A brief description of the refinements is provided on pages 2 and 3 of this MPR request and a list of refinements and the reason for each is provided in Attachment A: Refinement Table and Project Impacts Table.

Table 1: Project Refinement Table lists each refinement alphabetically by Transmission Line (TL) 625B and TL629E as part of the San Diego Gas & Electric Company (SDG&E) Cleveland National Forest Power Line Replacement Projects (Project). The refinements are a result of the Project's final design and a brief explanation of the need for each refinement is included. This table also includes the temporary and permanent impacts associated with the requested refinements by type and alignment.

**Cleveland National Forest
Power Line Replacement Projects**

**Attachment D:
Compare Map
TL625B Map 10 of 39**

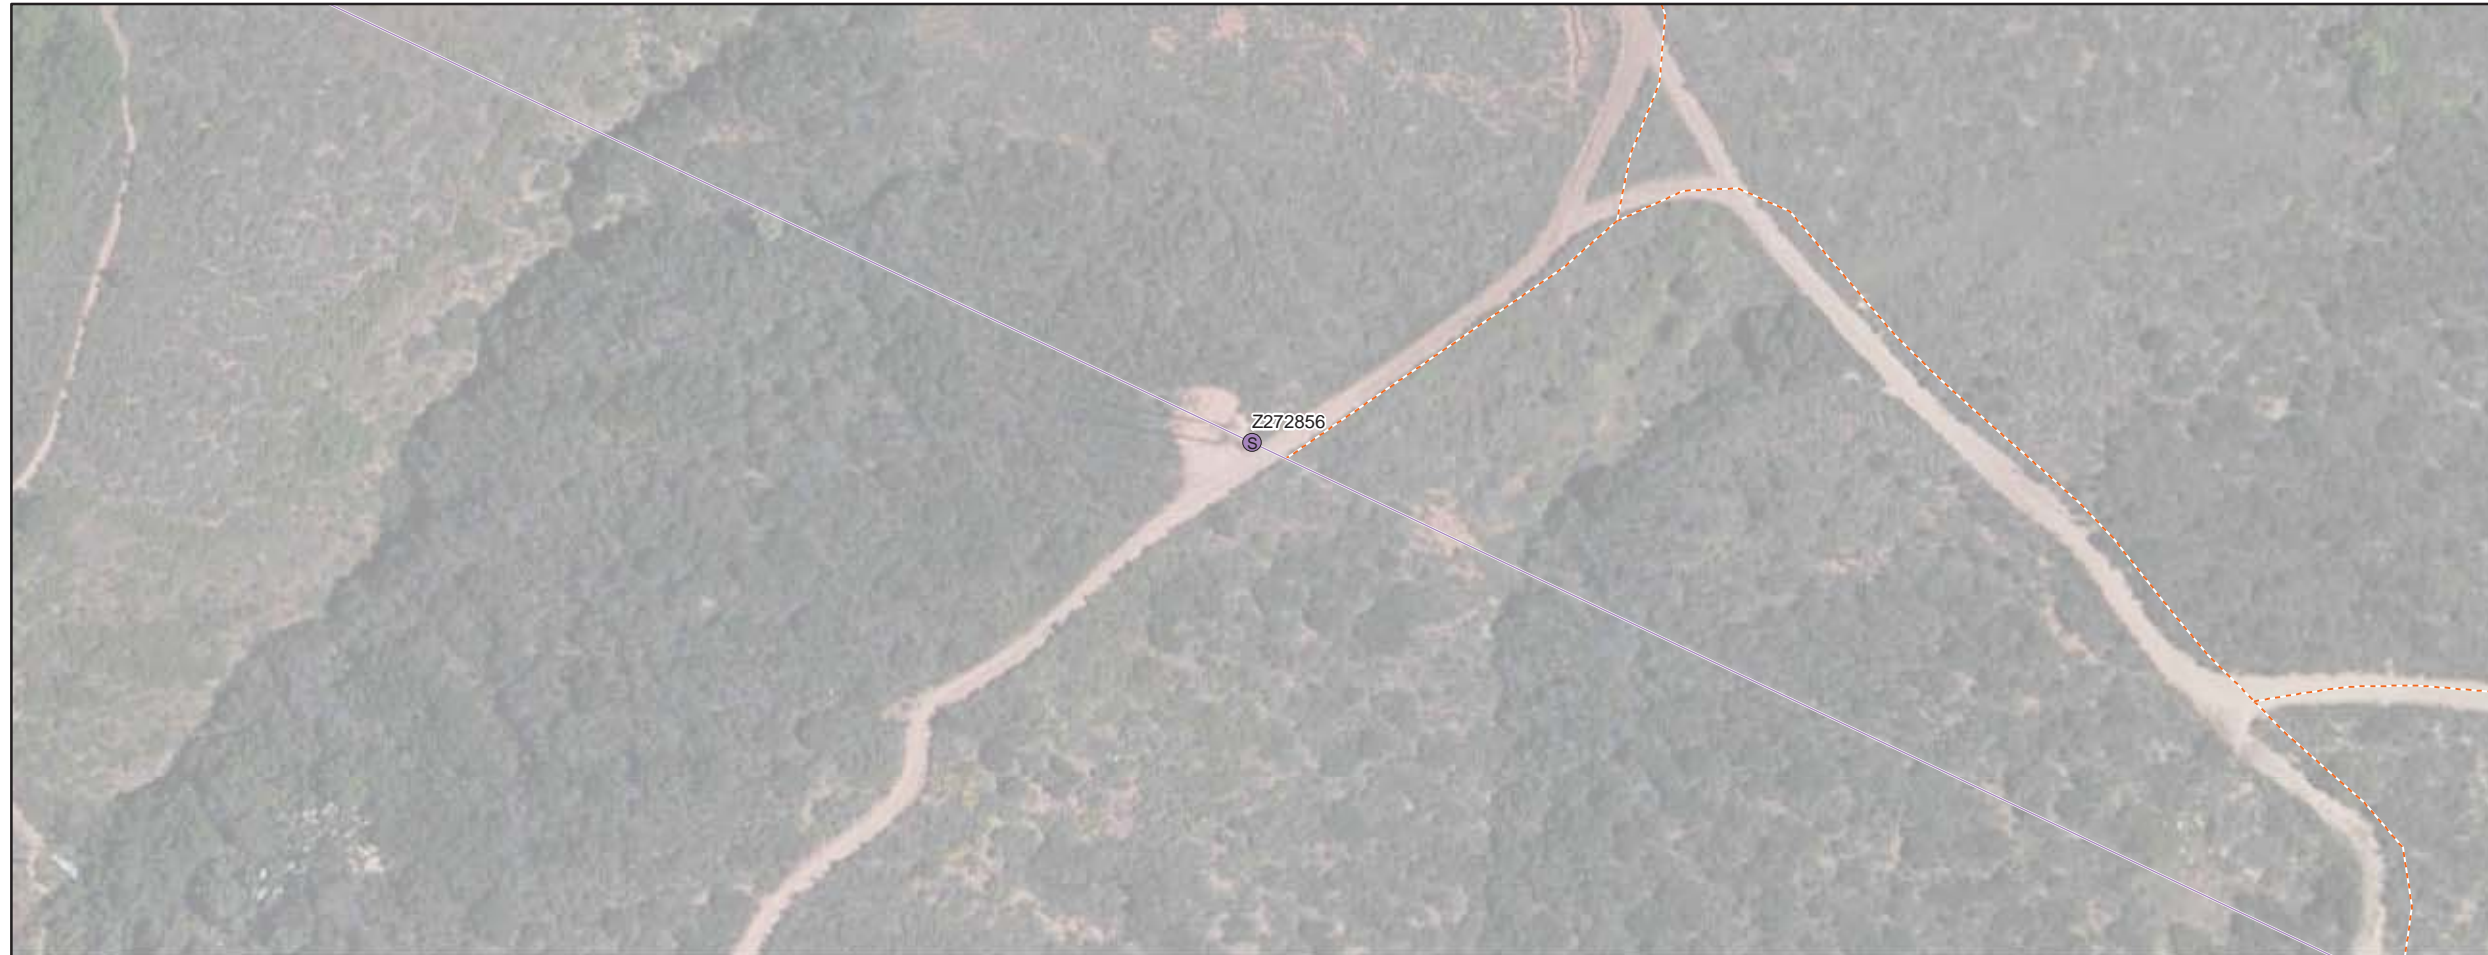
TW-06	7 of 39	Enlargement of an approved temporary workspace	The temporary workspace is being enlarged to accommodate equipment, allow vehicle turnaround, and safely conduct pole work at Pole Z272852.
TW-07	10 of 39	Enlargement of an approved temporary workspace	The temporary workspace is being enlarged to accommodate equipment and safely conduct pole work at Pole Z272856.
TW-08	14 of 39	Addition of a new temporary workspace	The temporary workspace is being added to accommodate equipment and safely conduct pole work as well as the access road realignment work at Pole Z272867.
TW-09	15 of 39	Addition of a new temporary workspace	The temporary workspace is being added to conduct pole top work at Pole P275703.
TW-10	20 of 39	Addition of a new temporary workspace	The temporary workspace is being added to conduct pole top work at Pole P776550.
TW-11	21 of 39	Addition of a new temporary workspace	The temporary workspace is being added to conduct pole top work at Pole P774217.

**Attachment D:
Compare Map
TL629E Map 3 of 46**

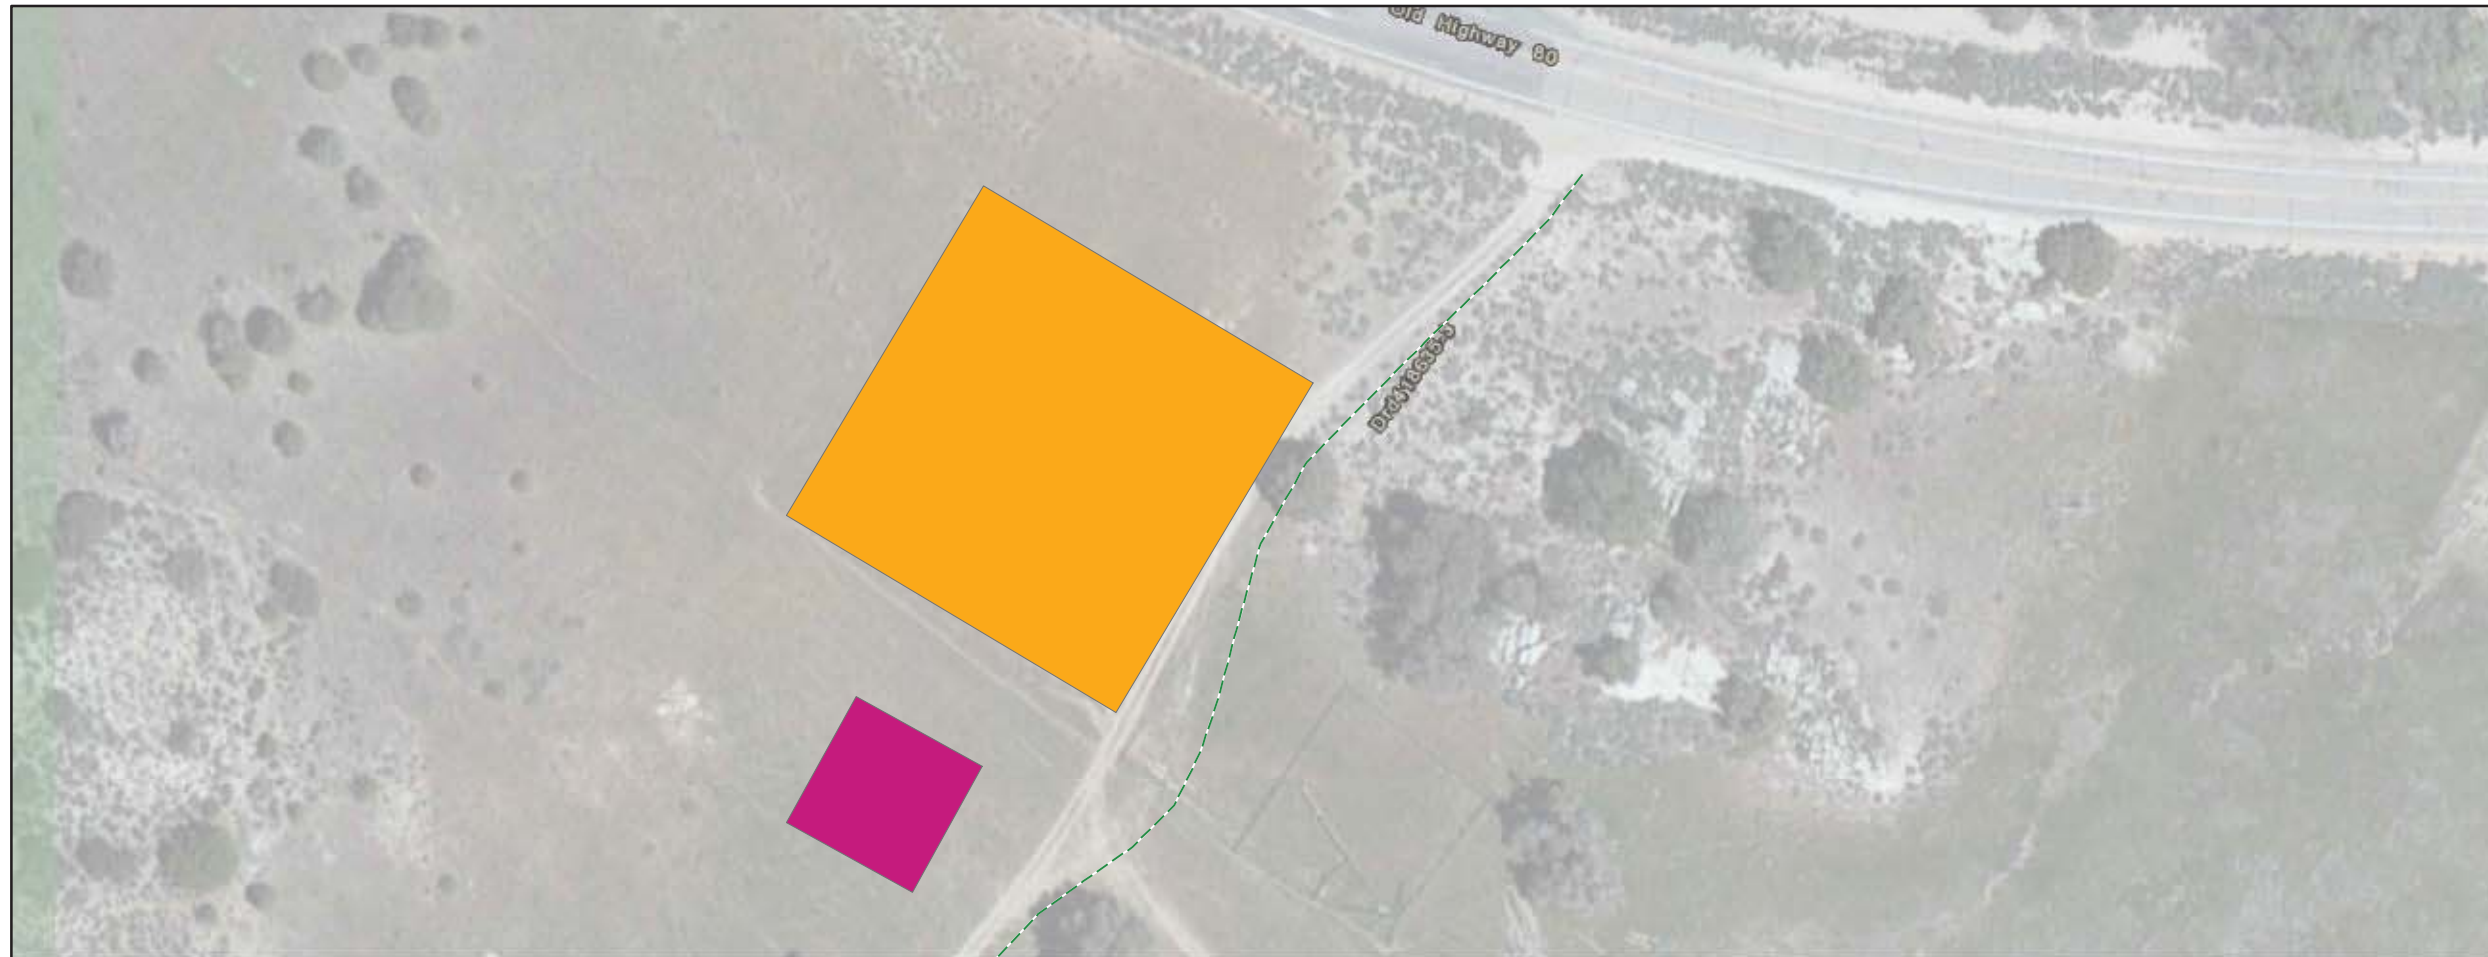
Workspace	Compare Map Number	Refinement	Need for Refinement
Permanent Impacts: 0.00 acres			
TWE-09	3 of 46	Addition of a new temporary work entry area	The temporary work entry area is being added to accommodate equipment and provide safe access to the Kitchen Creek Staging Yard.
TWE-10	5 of 46	Addition of a new temporary work entry area	The temporary work entry area is being added to accommodate vehicle and equipment parking for Pole Z40585.
TWE-11	9 of 46	Addition of a new temporary work entry area	The temporary work entry area is being added to provide access to an existing navigation access road.
TWE-12	27 of 46	Addition of a new temporary work entry area	The temporary work entry area is being added to accommodate equipment and vehicle turnaround near Pole Z44185.
TWE-13	33 of 46	Addition of a new temporary work entry area	The temporary work entry area is being added to accommodate equipment as well as provide vehicle turnaround and access to stringing sites near Pole Z44205.

**Attachment D:
Compare Map
TL629E Map 8 of 46**

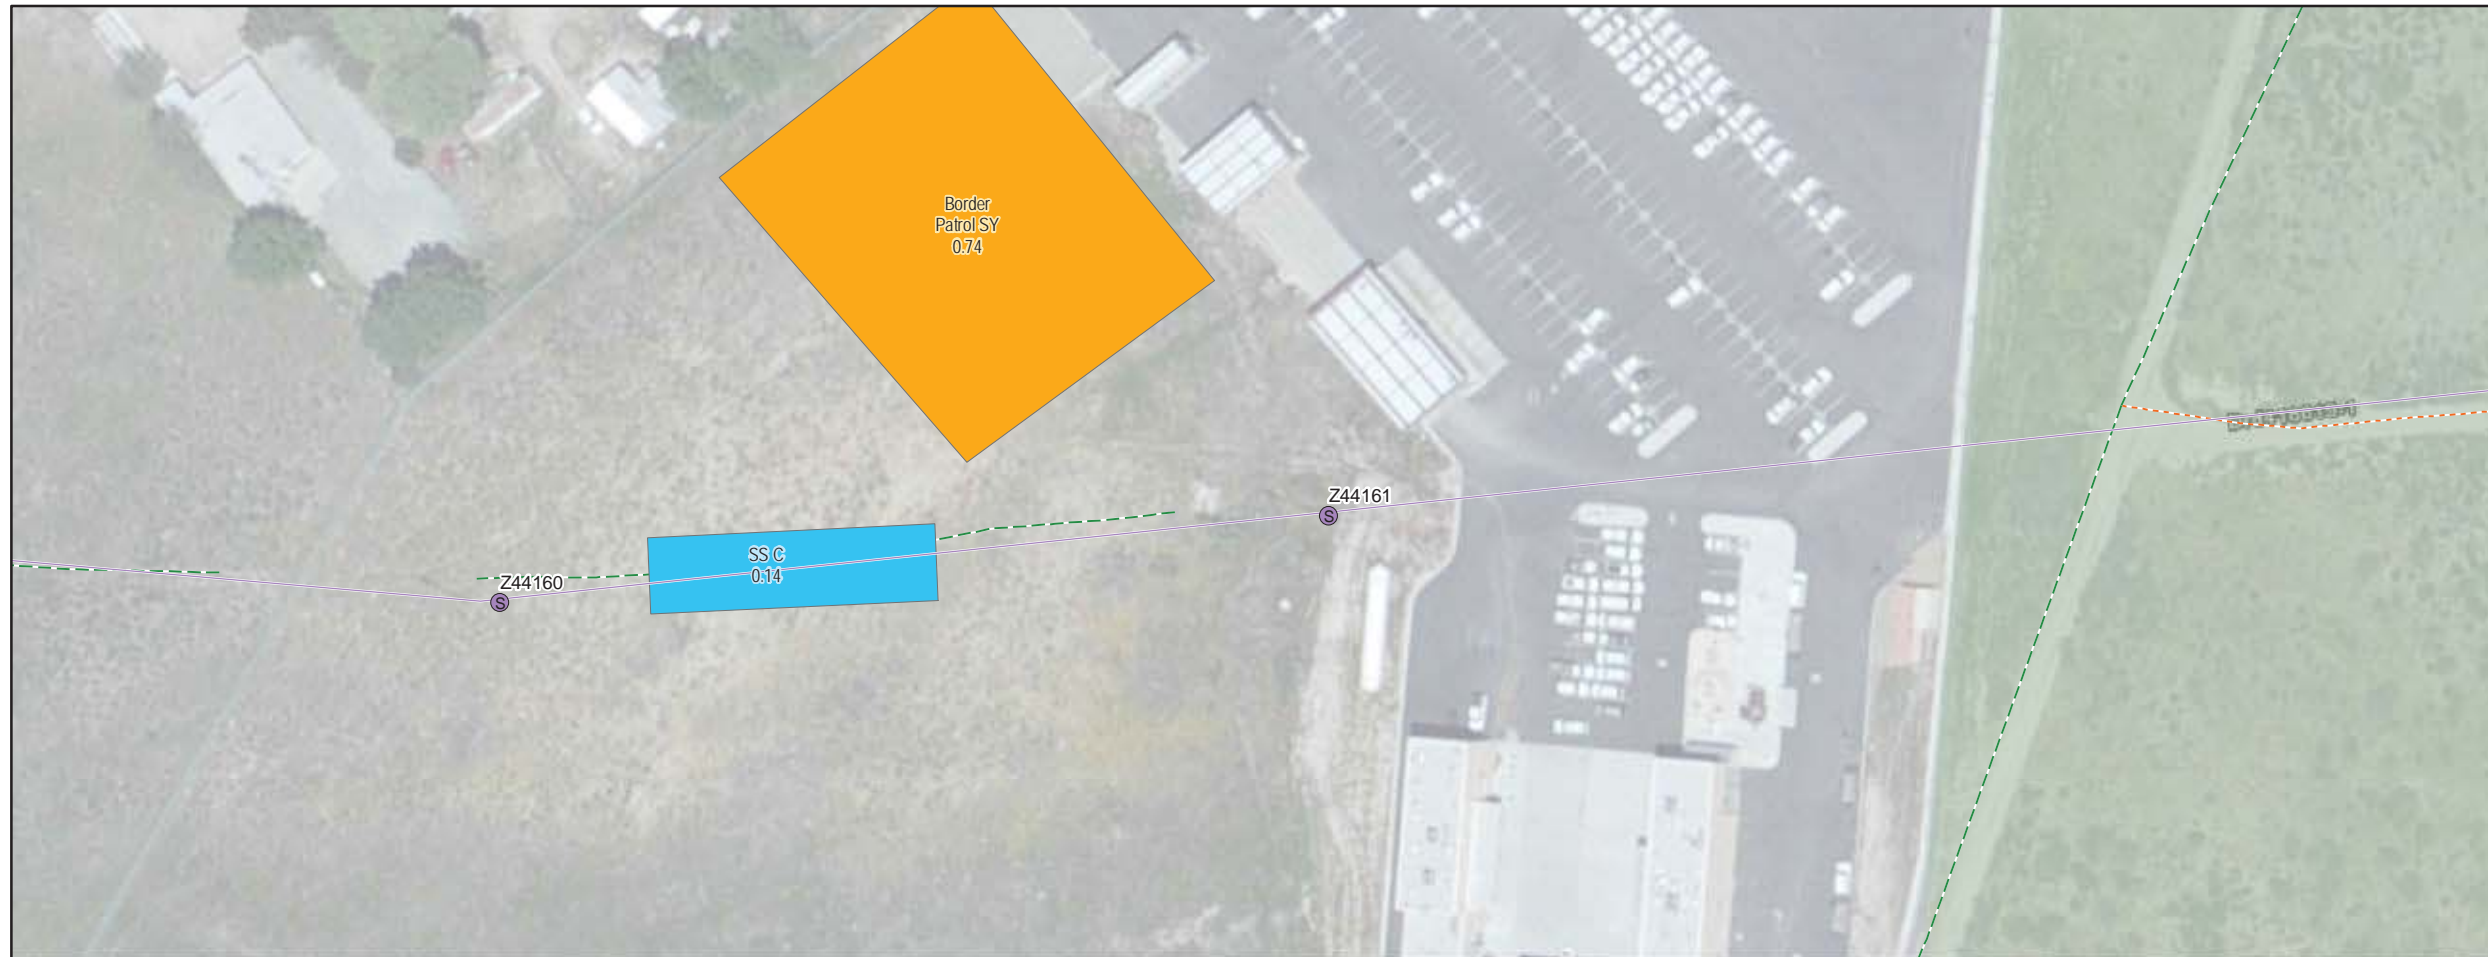
Workspace	Compare Map Number	Refinement	Need for Refinement
Temporary Impacts: 0.00 acres³			
Permanent Impacts: 0.00 acres			
GS-08	8 of 46	Addition of a temporary guard structure work area	Guard structure work areas have been added throughout the transmission alignments to better protect existing distribution and communication lines that cross the transmission line corridor, as well as to better protect traffic during installation and removal of conductor at road crossings.
GS-09	8 of 46	Addition of a temporary guard structure work area	Guard structure work areas have been added throughout the transmission alignments to better protect existing distribution and communication lines that cross the transmission line corridor, as well as to better protect traffic during installation and removal of conductor at road crossings.
GS-10	9 of 46	Relocation and enlargement of an approved guard structure work area	Guard structure workspaces have been relocated and enlarged throughout the transmission alignments to better protect existing distribution and communication lines that cross the transmission line corridor, as well as to better protect traffic during installation and removal of conductor at road crossings.

**Attachment D:
Compare Map
TL629E Map 33 of 46**

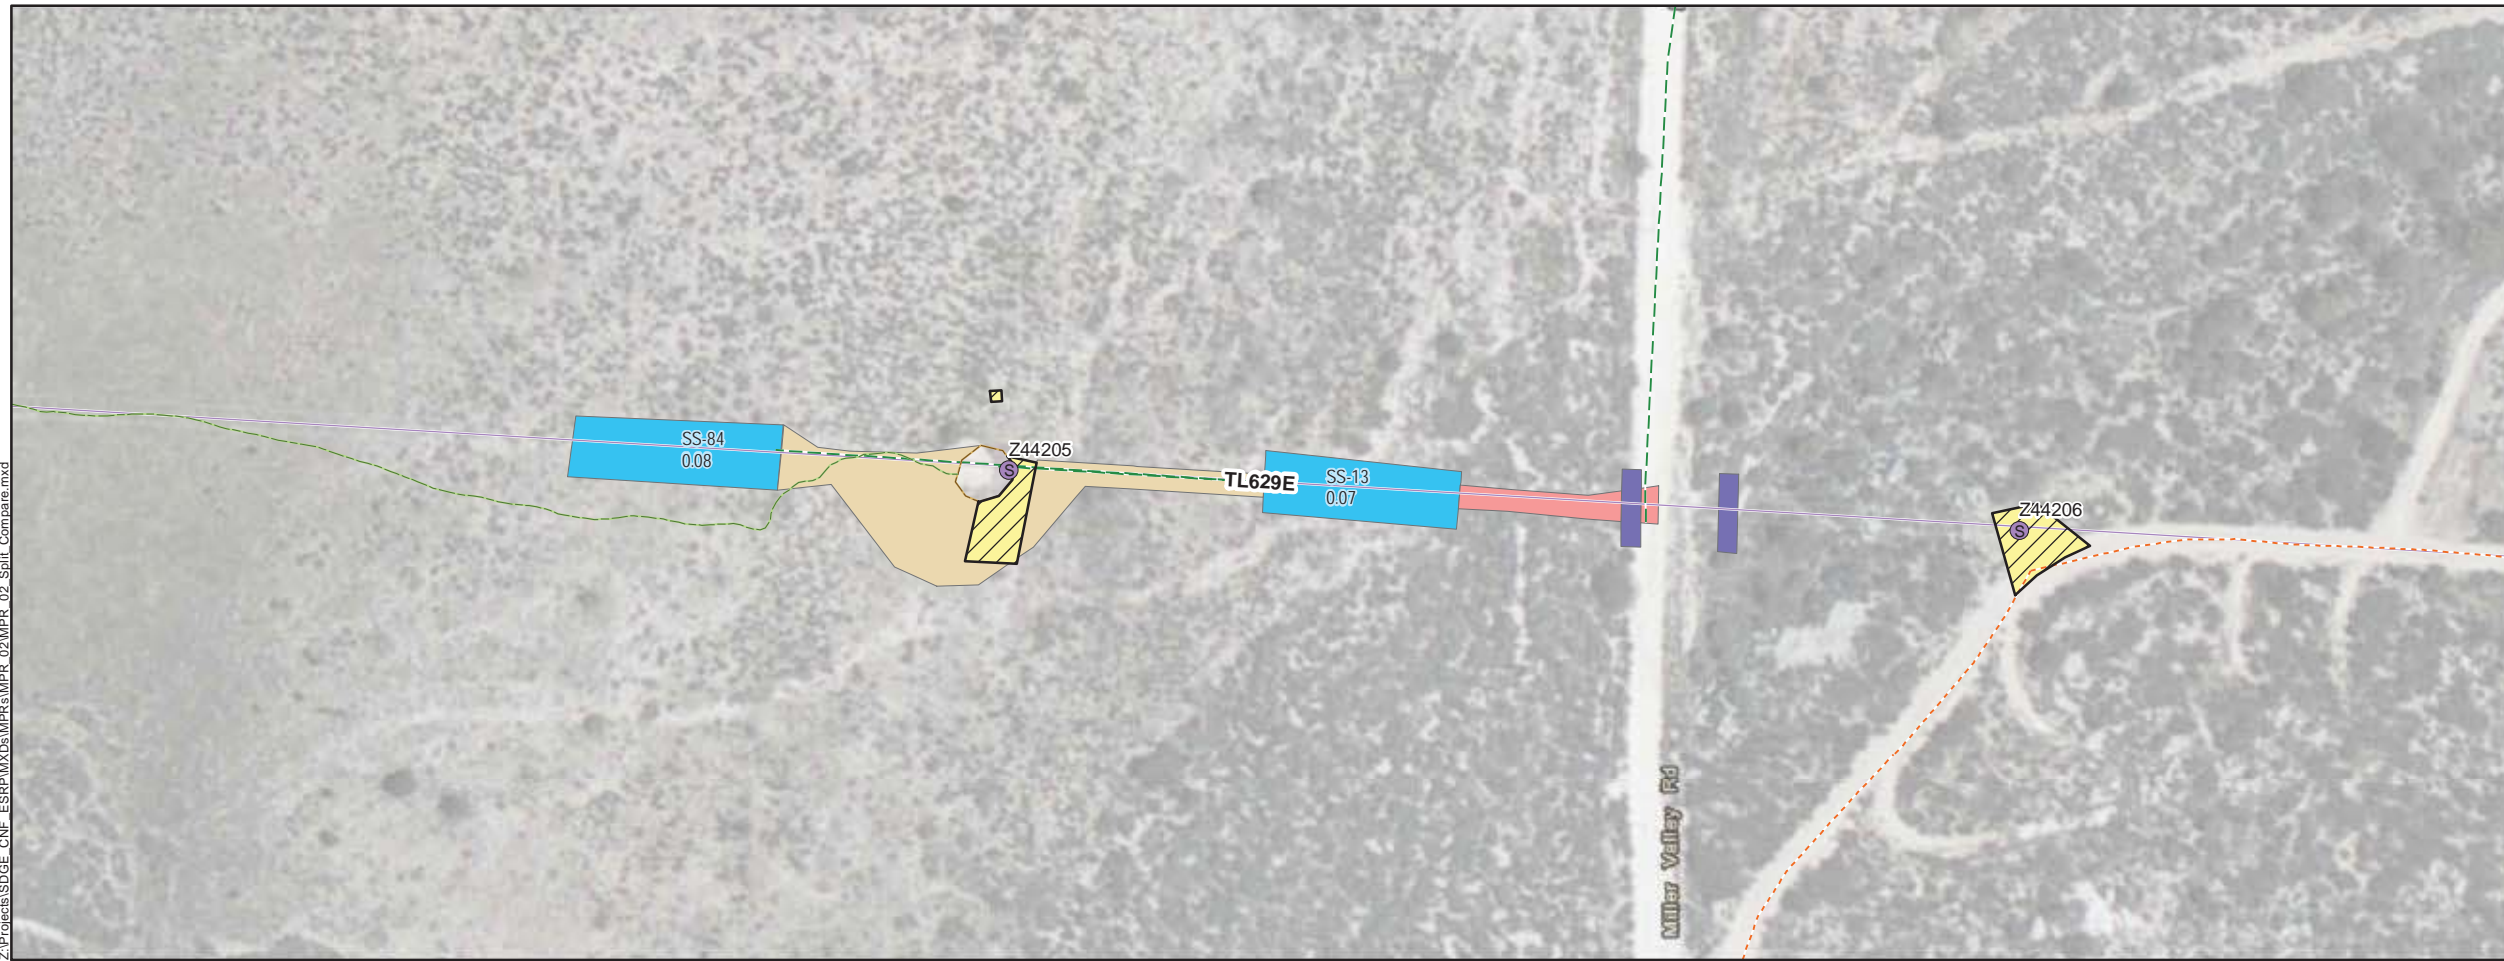
GS-14	33 & 35 of 46	Addition of a temporary guard structure work area	Guard structure work areas have been added throughout the transmission alignments to better protect existing distribution and communication lines that cross the transmission line corridor, as well as to better protect traffic during installation and removal of conductor at road crossings.
GS-15	37 of 46	Addition of a temporary guard structure work area	Guard structure work areas have been added throughout the transmission alignments to better protect existing distribution and communication lines that cross the transmission line corridor, as well as to better protect traffic during installation and removal of conductor at road crossings.
GS-16	44 of 46	Relocation and enlargement of an approved guard structure work area	Guard structure workspaces have been relocated and enlarged throughout the transmission alignments to better protect existing distribution and communication lines that cross the transmission line corridor, as well as to better protect traffic during installation and removal of conductor at road crossings.

SS-84	33 of 46	Addition of a new stringing site measuring approximately 0.08 acre	The stringing site was added to better align with the final engineering of terminal dead ends and provide more adequate pulling tensions. Additionally, the stringing site better aligns with the transmission line, which reduces pulling tensions and helps prevent potential stringing operation complications and conductor damage.
SS-13	33 & 35 of 46	Addition of a new stringing site measuring approximately 0.07 acre	The stringing site was added to better align with the final engineering of terminal dead ends and provide more adequate pulling tensions. Additionally, the stringing site better aligns with the transmission line, which reduces pulling tensions and helps prevent potential stringing operation complications and conductor damage.
SS-14	35 of 46	Reconfiguration of the approved stringing site dimensions and size from approximately 0.06 acre to 0.08 acre	The stringing site was reconfigured to better align with the final engineering of terminal dead ends and provide more adequate pulling tensions. Additionally, the stringing site better aligns with the transmission line, which reduces pulling tensions and helps prevent potential stringing operation complications and conductor damage.
